**Thursday, June 30, 2022
7:00 P.M.**

D. PSPR22-0008 – Site Plan review for Texas Road House, located 18055 Siler Parkway, zoned GBD, General Business District/PUD, Planned Unit Development, requesting to construct a new 8,039 square foot restaurant.

See Shopping Center Site Plan Submission below:

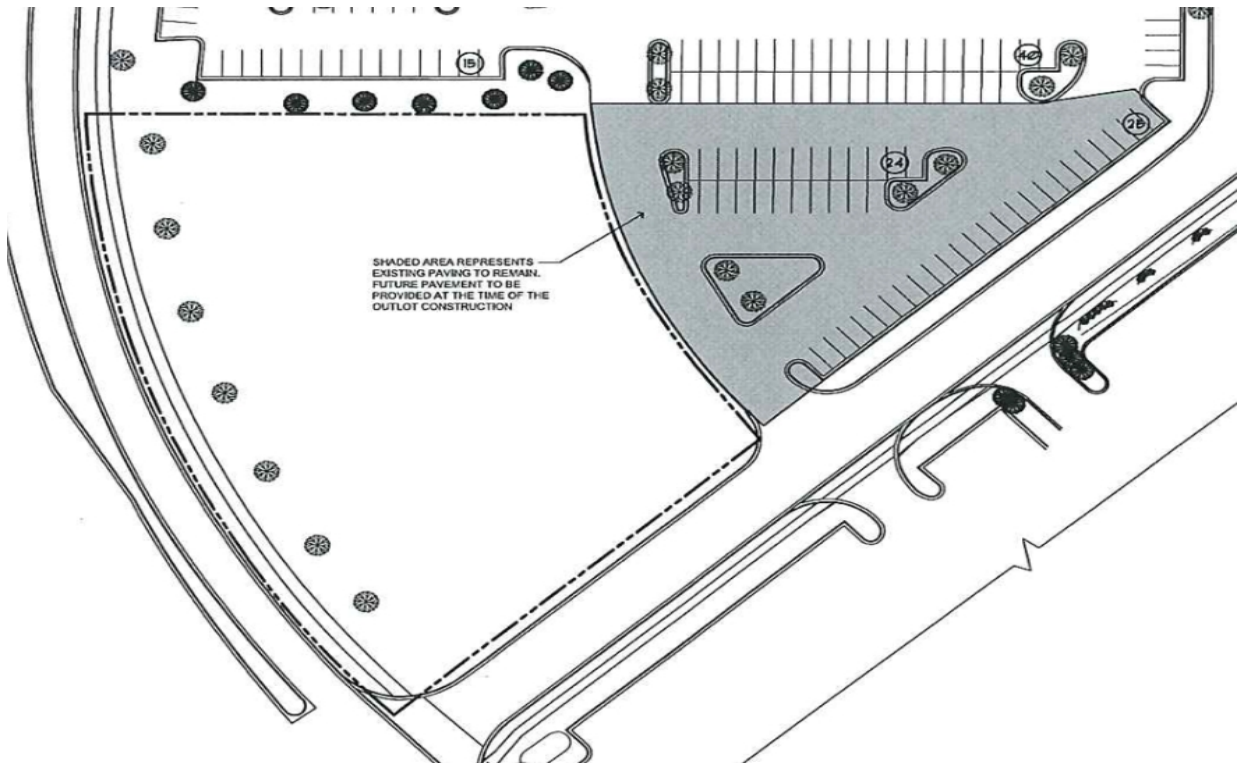
7. Shared Parking. Although 134 parking spaces are required and only 96 are provided on-site, there is a sufficient supply of available parking spaces in the shopping center lot to the east. The following items must be considered:

a. The Silver Lake Village PUD provides for shared parking between units and the owner of the center must also recognize that parking spaces need to remain available for shared use by Texas Roadhouse. Since this project is being utilized through a land lease, a unit split or easement would only be necessary in the event of separate ownership between the out lot and shopping center. We recommend that a written understanding of the parking arrangement be submitted by the property owner.

b. The Planning Commission previously allowed deferment of pavement replacement for the parking lot opposite the subject site. This parking area must now be re-paved and striped, per the agreement with the Planning Commission when the shopping center was redeveloped.

c. Although a striped area for pedestrian crossing is provided across the drive lane to the east of the building, it is close to the corner and could present a hazard with incoming traffic. We recommend that the pedestrian crossing be located farther to the north to provide a safer crossing location.

d. The developer indicated that he might want a portion of the parking lot to be converted to an out lot in the future, but shared use of these parking spaces might eliminate that option.
